**TO:** Mills City Council  
**FROM:** Megan Nelms, AICP, City Planner  
**DATE:** February 12, 2024  
**SUBJECT:** 257 Business Park – Final Plat

**Case Number:** 23.08 FSP

## 257 Business Park

# FINAL PLAT OF 257 BUSINESS PARK

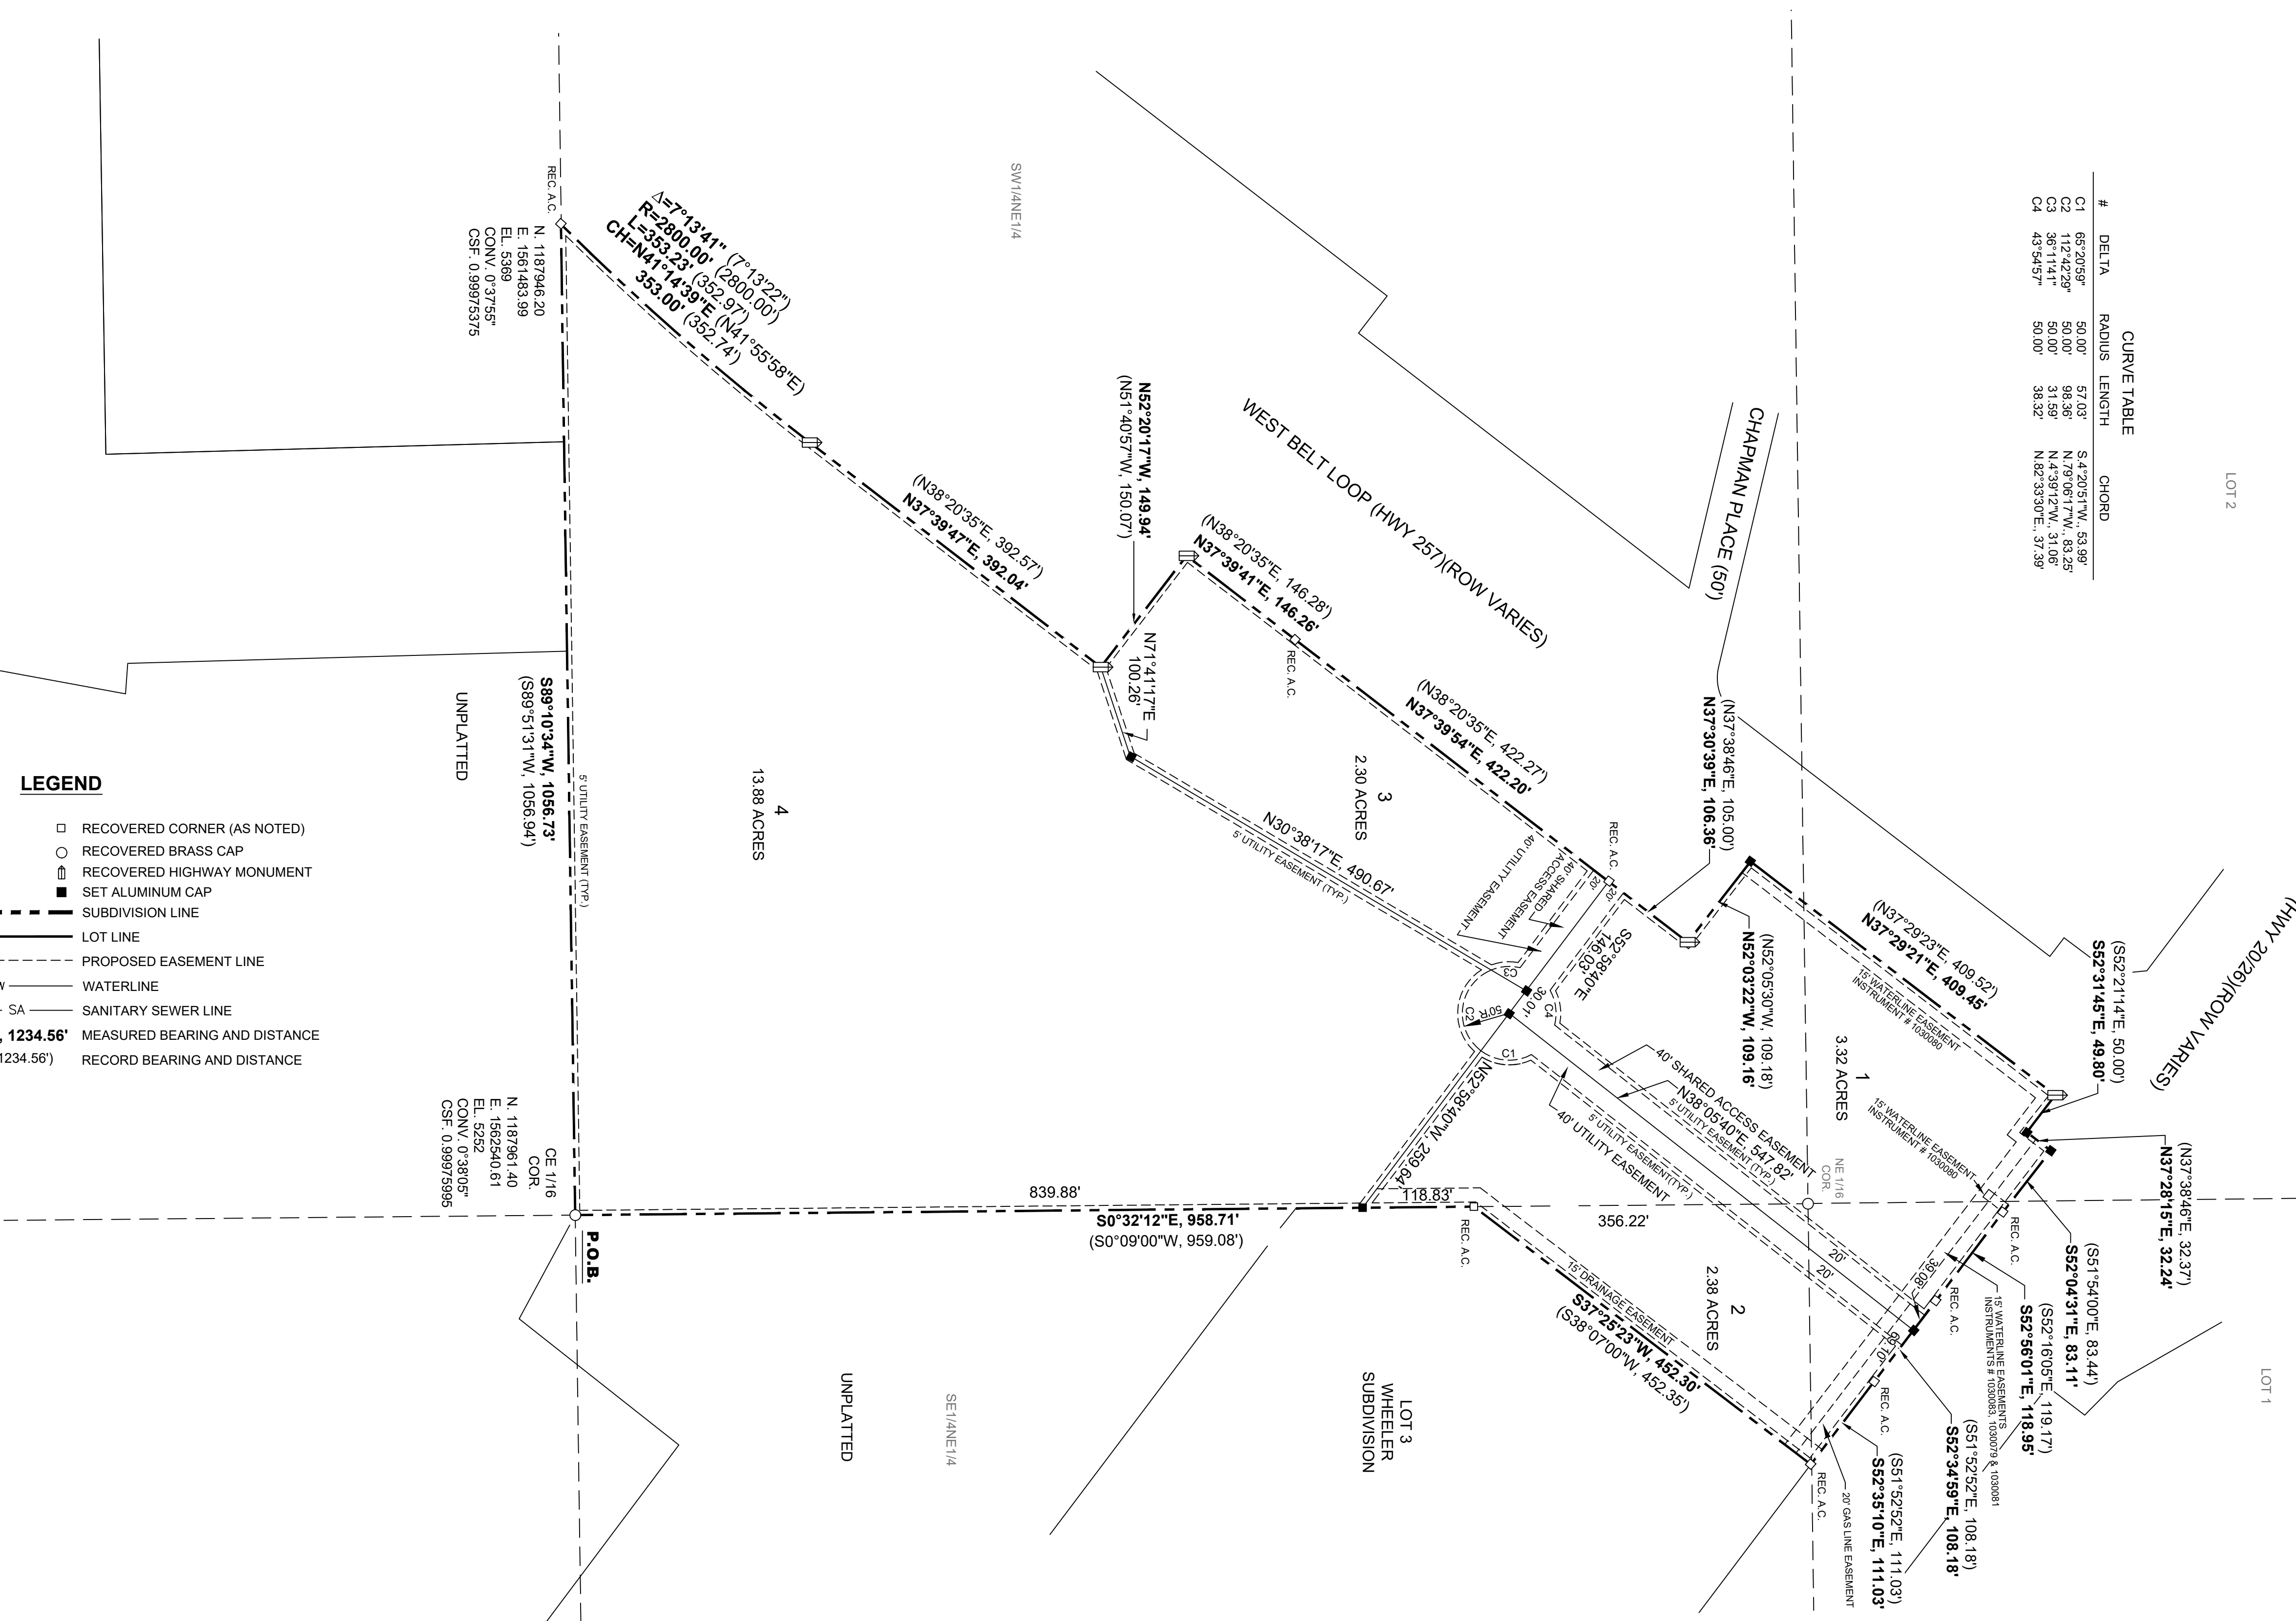
- a. Timeline for Permit to Construct
  7. All cul-de-sacs shall have a diameter of no less than 96’.
  8. Delineate the drainage easement/retention area on one of the lots.

9. Survey Review:
    - a. Add State Plane Coordinates, northing, easting, elevation, Convergence and Combined Factor to two (2) of the exterior corners.

- b. The coordinates are in grid but the distances are in ground
    - c. Verify the north corner(s) of the plat and Lot 1. Review Instrument #866007 as excepted in Instrument #1143765, with regard to the WYDOT parcel.

- d. There is a mis-closure of Lot 4 by 1.63 feet
  10. Cosmetic Revisions to the Plat:
    - a. Add TO THE CITY OF MILLS under “Plat of 257 Business Park” in the title block on both plat sheets.

- b. Make the adjacent subdivision and road names gray.
- 
-
